1.1 PROJECT INFORMATION

- A. Project Name: 2022 Renovation Work
- B. Owner: Glen Ellyn SD 41
- C. Architect: GreenAssociates, Inc.
- D. Architect Project Number: 13100-2021014
- E. Date of Addendum: 20 October 2021

**2022 RENOVATION WORK**  
HADLEY JUNIOR HIGH SCHOOL  
240 HAWTHORNE BOULEVARD, GLEN ELLYN, ILLINOIS 60137  
GLEN ELLYN SCHOOL DISTRICT 41  
793 NORTH MAIN STREET, GLEN ELLYN, ILLINOIS 60137

**PARTITION TYPES - ADDENDUM 1**

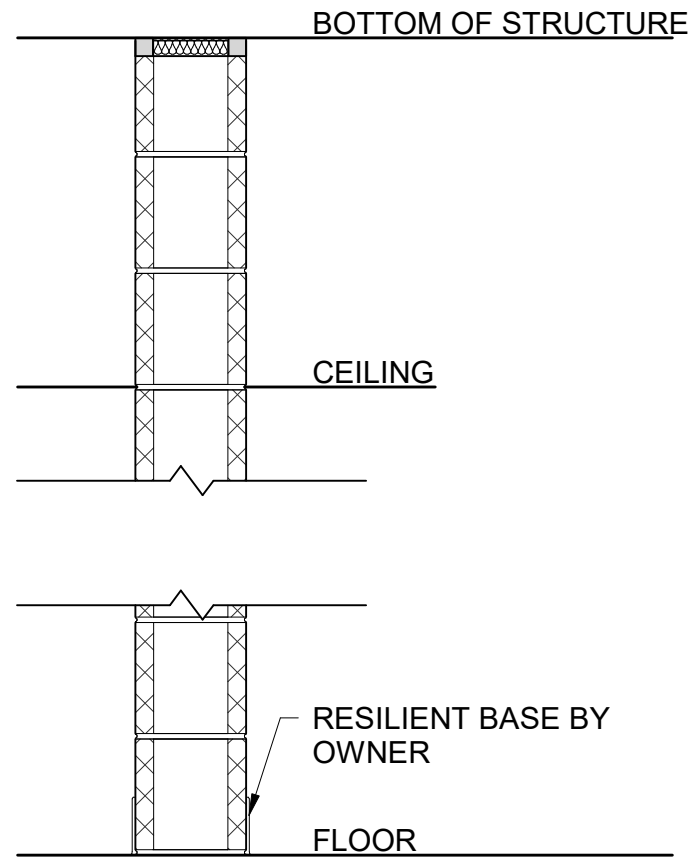
**PARTITION TYPE A**  
 FULL HEIGHT, FIRE RATED, CMU PARTITION

TYPE	THICKNESS	RATING (HRS)	U.L. DESIGN	NOTES
A4.1	3 5/8"	1	U905	
A4.2	3 5/8"	1	U905	1

- CONSTRUCTION TO BE GLAZED BLOCK AND CMU. MATCH EXISTING COURSING. SEE INTERIOR ELEVATION.
